**Norfolk Vanguard Offshore Wind Farm**

## **Norfolk County Council Unresolved Traffic Matters Position Statement**

Document Reference: ExA; AS; 10.D9.7

Date: 06 June 2019

TITLE  
B1149 TRAFFIC MANAGEMENT  
TYPICAL AIL CABLE DRUM DELIVERY  
SWEEP PATH ANALYSIS

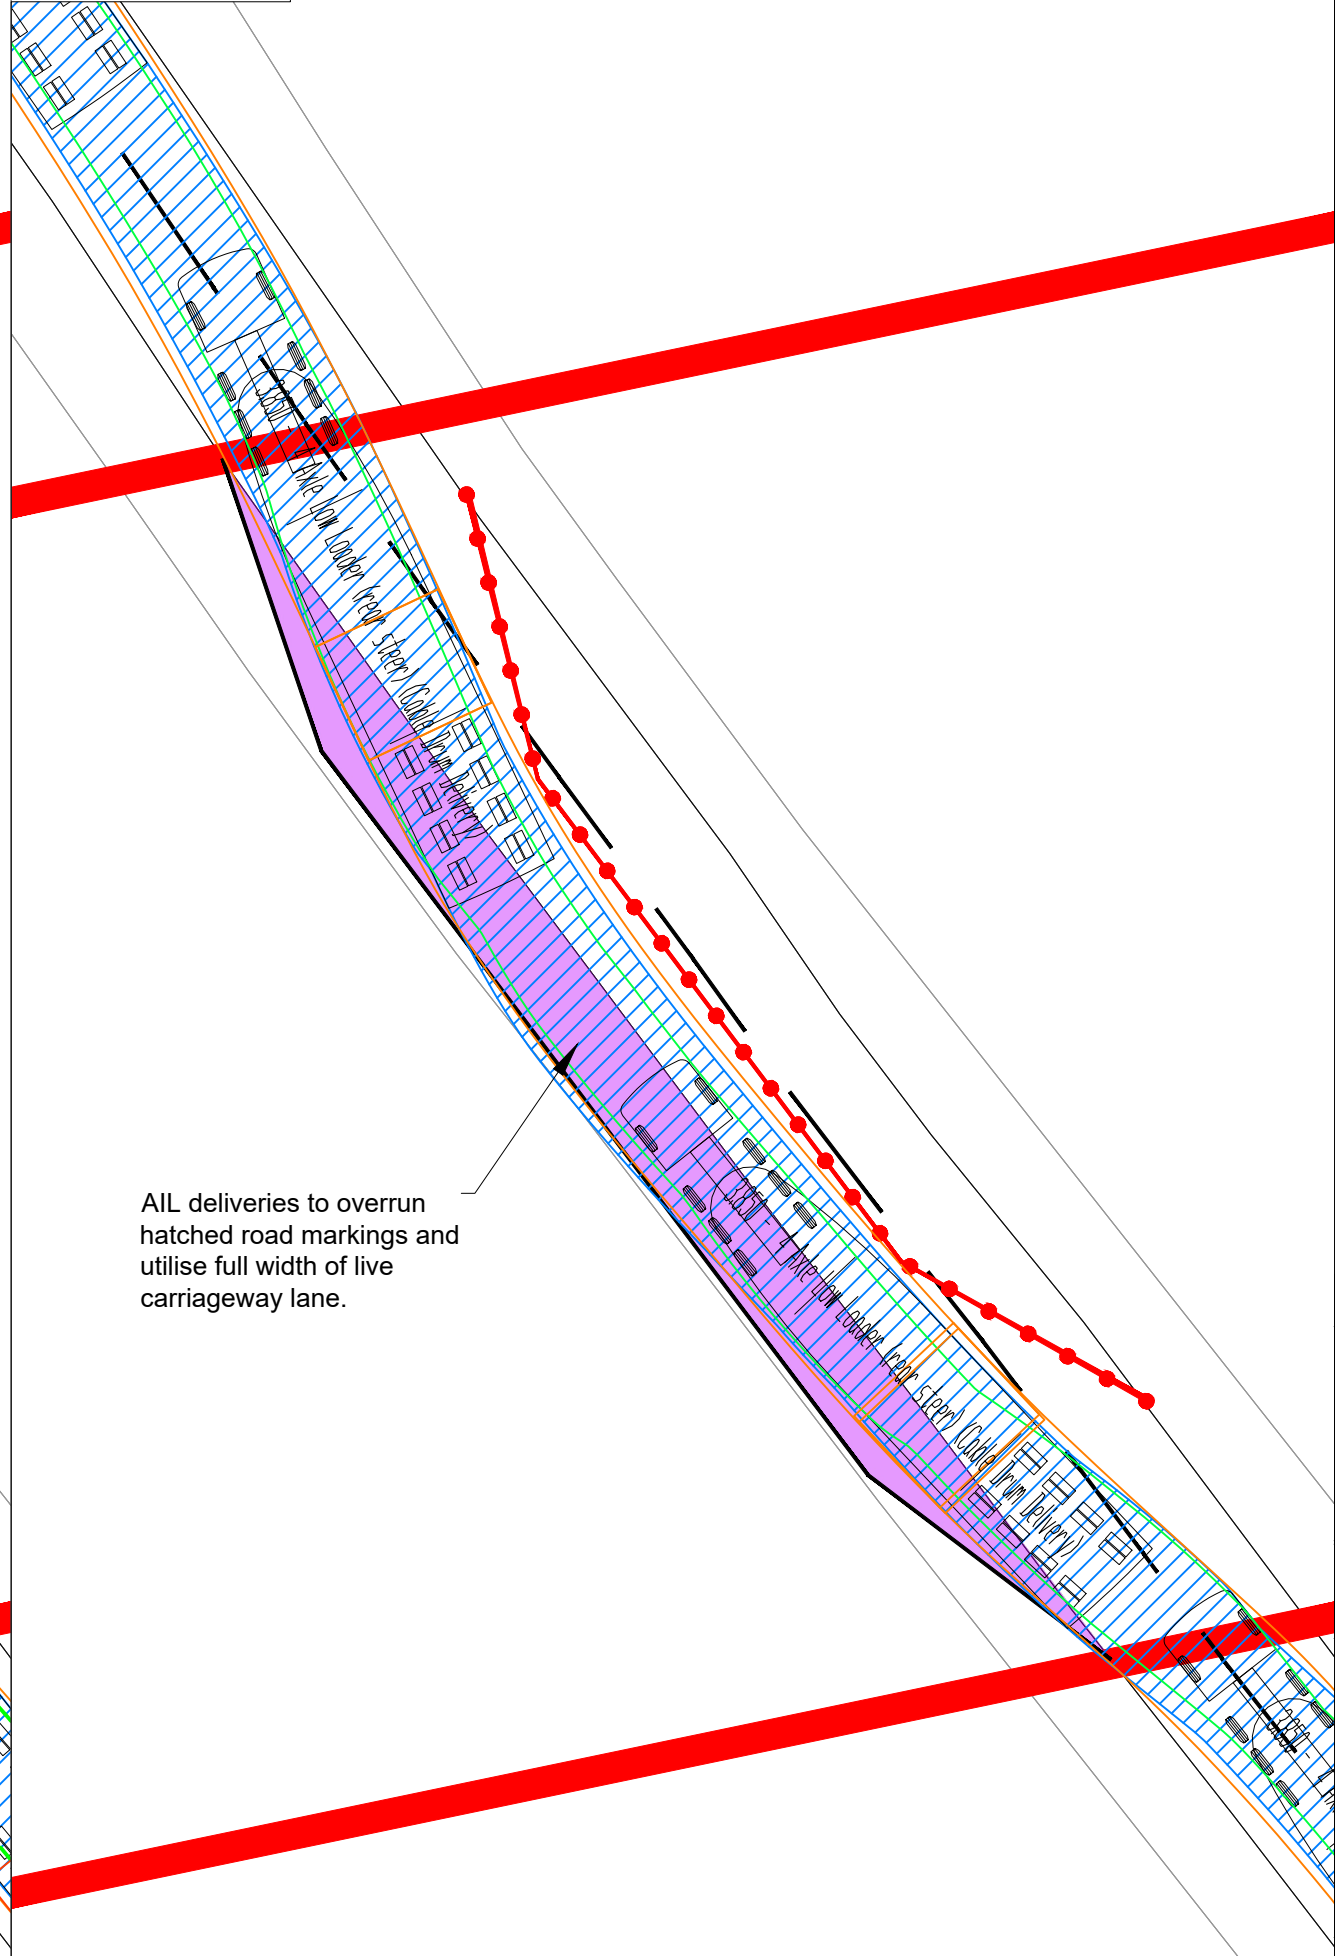
The swept path analysis does indicate that large, articulated vehicles will be able to negotiate the works area, albeit with very little clearance.

However, the swept path analysis is totally reliant upon a 0.5m safety zone outside the work area. (i.e. the buffer between vehicles and roadworks/the open trench excavation). This is a National Speed Limit road, so should have a 1.2 m safety zone. Whilst this can be reduced with the use of a Temporary 30mph Speed Restriction, it is not so in the case of the excavation exceeding 1.2 metre depth.

The safe working distance of 1.2m can readily be accommodated in the final design of these roadworks. The area of road widening (the pink area shown on the drawings in Appendix A) can be widened further to the west within the Order limits, and the coned off working area can be narrowed from 20m down to 15m if required as there will be no requirement to maintain a running track between the cable trenches. This would provide additional space for vehicles to manoeuvre (combined with extending the road further to the west) to ensure that the swept path remains safely negotiable, whilst at the same time maintaining a safe working area. In addition, speed restrictions can be introduced for vehicles as they traverse the single lane management. Alternatively the 1.5m deep excavation can be designed to provide additional lateral support to minimise the risks associated with working in proximity to deep excavation and ensuring a 0.5m distance of separation would be safe. These options are all within the control of the Applicant and can be readily addressed during detailed design. As Norfolk County Council highlight in their position at the 30.05.2019, land within the highway boundary, outside of the Order limits, would also be available to extend the tapers of the road widening if required, depending on the final design of the roadworks.

The roadworks required for abnormal loads as described will be required for approximately one week. The final design of the proposed roadworks will form part of the final Traffic Management Plan secured under Requirement 21. Any works proposed in this area may not commence until a Traffic Management Plan (including the detailed design of the roadworks proposed along the B1149) has been submitted to and approved by the relevant planning authority in consultation with the highway authority, i.e. approval from Norfolk County Council as Local Highway Authority of the detailed design of these roadworks will be required post-consent before the works can proceed.
